MIL-C-60577(MU)
AMENDMENT 2
28 September 1973
SUPERSEDING
AMENDMENT 1
27 September 1972

MILITARY SPECIFICATION

CIRCUIT CARD ASSEMBLY - THOUSANDS DECADE
MEMORY AND READOUT - A2: 10547220

This amendment forms a part of Military Specification MIL-C-60577(MU) dated 18 June 1970.

FIGURE 2

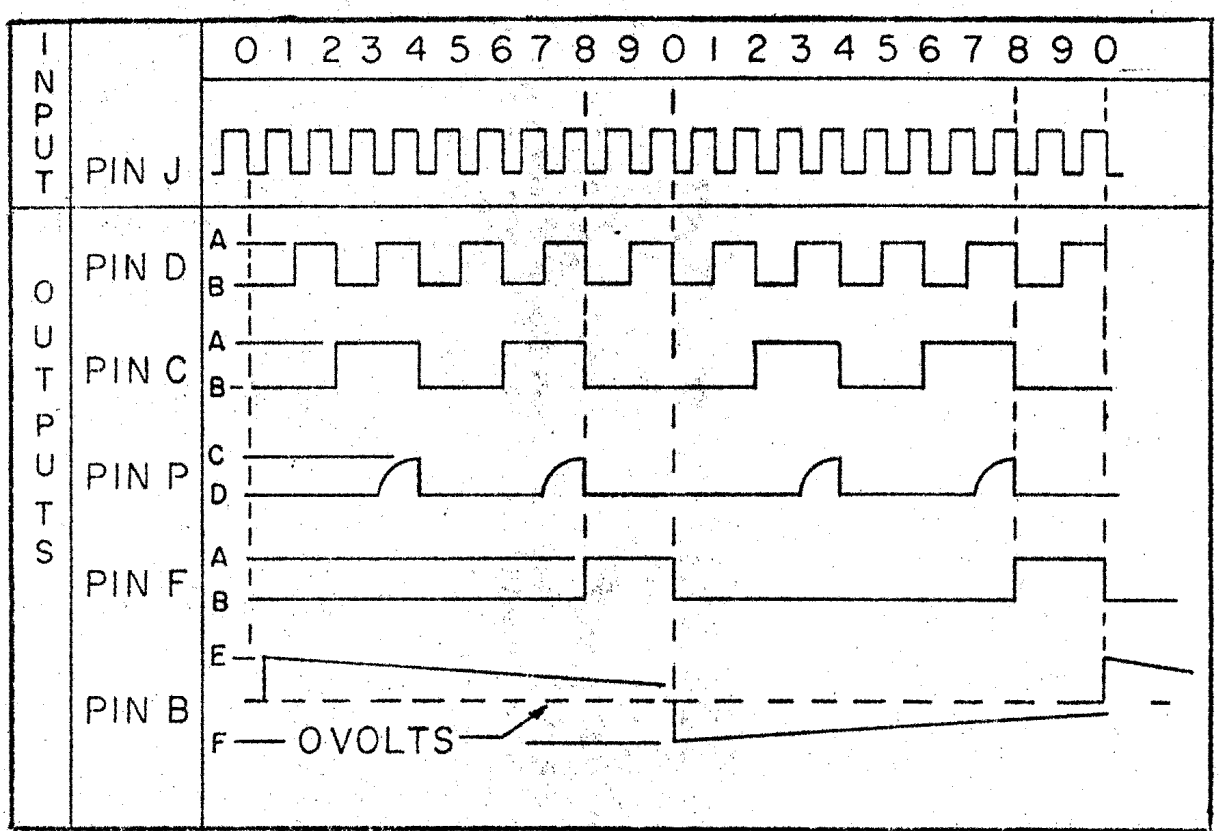
FIGURE 2: Delete in its entirety and substitute:

AMPLITUDES

+70°F	+155°F	-65°F
A	1.0V MIN	.85V MIN	1.2V MIN
B	.21V MAX	.28V MAX	.20V MAX
C	.8V MIN	.8V MIN	.8V MIN
D	.3V MAX	.3V MAX	.3V MAX
E	1.2V MIN	1.2V MIN	1.2V MIN
F	-1.2V MIN	-1.2V MIN	-1.2V MIN
